Access Compliance Report Public Rights-of-Way (Curb Ramps)

Main Street: N/A Cross Street: AURA_LN Location: SW

ADA ID: RPRK211028123257 Ramp Type: Type 4 - Parallel Initial Pass/Fail: Fail Overall Compliance: No Severity Score: 2

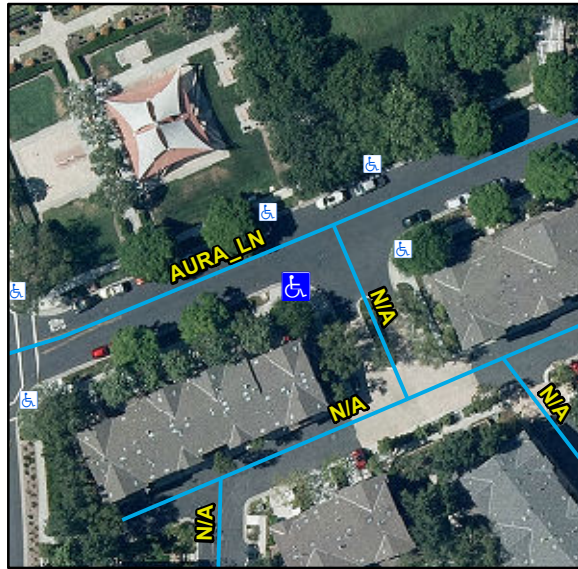
Compliance	Description	Data	Compliance	Description	Data
N/A	Ramp Length LT (in)	123	N/A	Ramp Length RT (in)	133
Yes	Ramp Width LT (in)	89	Yes	Ramp Width RT (in)	90
Yes	Ramp Run Slope LT (%)	0.5	Yes	Ramp Run Slope RT (%)	3.8
No	Ramp Cross Slope LT (%)	2.3	No	Ramp Cross Slope RT (%)	2.2
N/A	Landing Present	N/A	N/A	DWS Provided	N/A
N/A	Landing Length (in)	N/A	N/A	DWS Contrast	N/A
N/A	Landing Width (in)	N/A	N/A	DWS Length (in)	N/A
N/A	Landing Run Slope (%)	N/A	N/A	DWS Full Width	N/A
N/A	Landing Cross Slope (%)	N/A		DWS Offset Type	N/A
N/A	Landing Movement Obstructed?	N/A	N/A	DWS Offset Left (in)	N/A
	Landing Movement Type	N/A	N/A	DWS Offset Right (in)	N/A
N/A	Landing Shared	N/A			
N/A	Clear Space	Yes			
N/A	Clear Space To Crosswalk (in)	N/A			
N/A	Marked Crosswalk 1	No	N/A	Marked Crosswalk 2	No
	Crossing 1 Direction	E		Crossing 2 Direction	N
	Marked Crosswalk 1 Width (in)	N/A		Marked Crosswalk 2 Width (in)	N/A

Remove & Replace Curb Ramp With Two New Directional Ramps or Equivalent.
